CERTIFICATE OF APPROPRIATENESS

Property: 802 W. Temple Street, Lot 9, Block 218, East Norhill Subdivision. The property includes a historic 2,004 square foot, one-story brick veneer single-family residence and a detached garage situated on a 6,157 square foot (59' x 104') corner lot.

Proposal: Alteration – Replace 19 original wood 1-over-1 sash windows with 19 1-over-1 wood replacement windows.

FIRST FLOOR PLAN

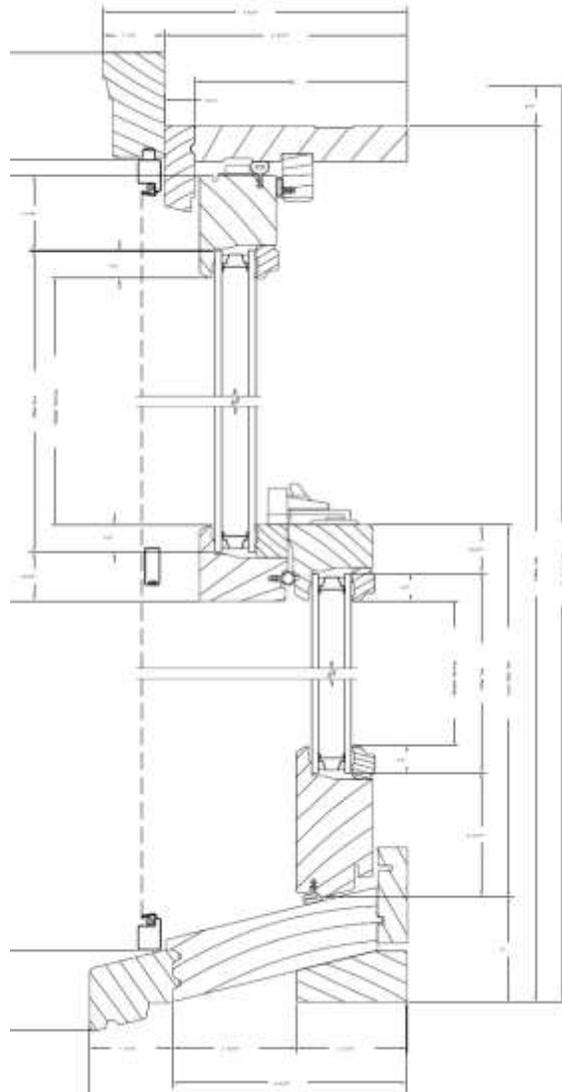
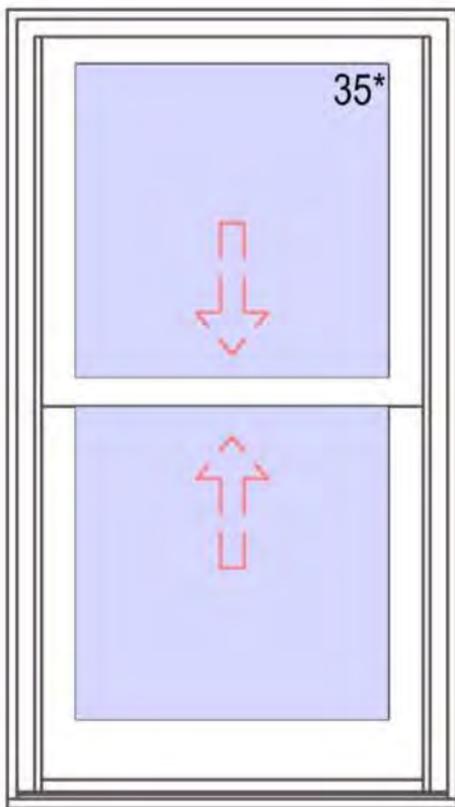
* WINDOWS THAT NEED IMMEDIATE REPLACEMENT, CAUSING WATER DAMAGE TO FLOORS AND STRUCTURE.

Approval to replace the bottom sash of window I and all exterior sills.

Denial to replace windows A, B, C, D, E, F, G, H, J, and K

WINDOW K

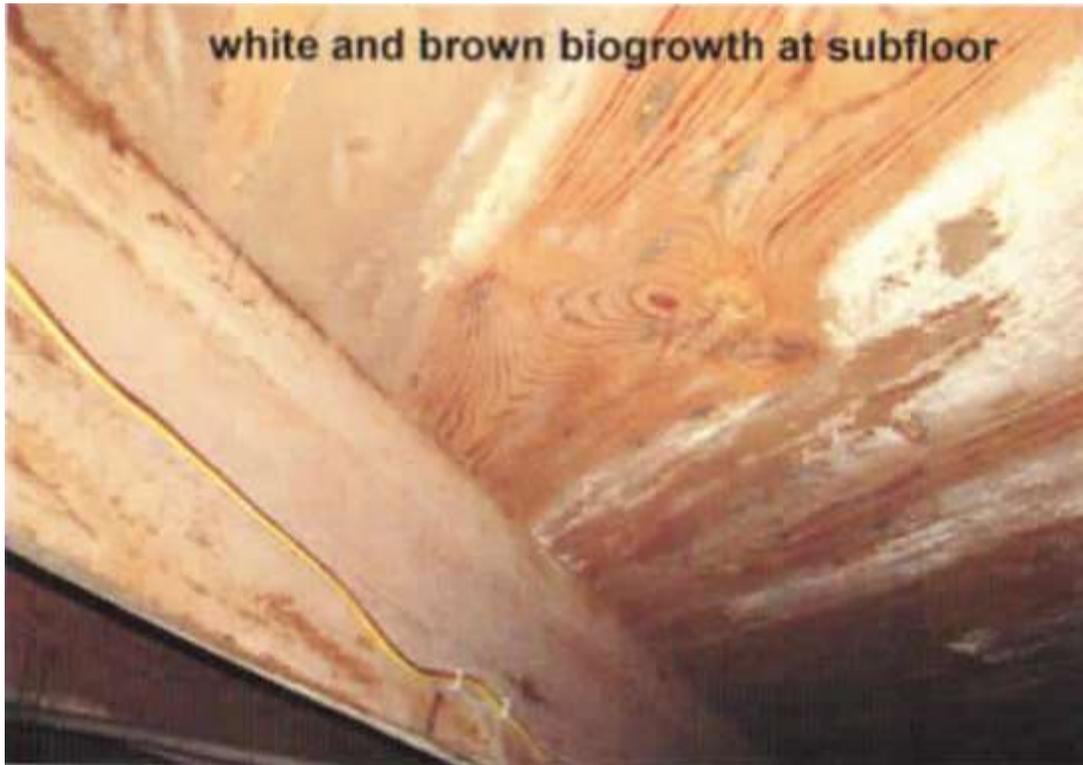
TYPICAL DAMAGE TO WINDOW K

TYPICAL DAMAGE TO WINDOW K
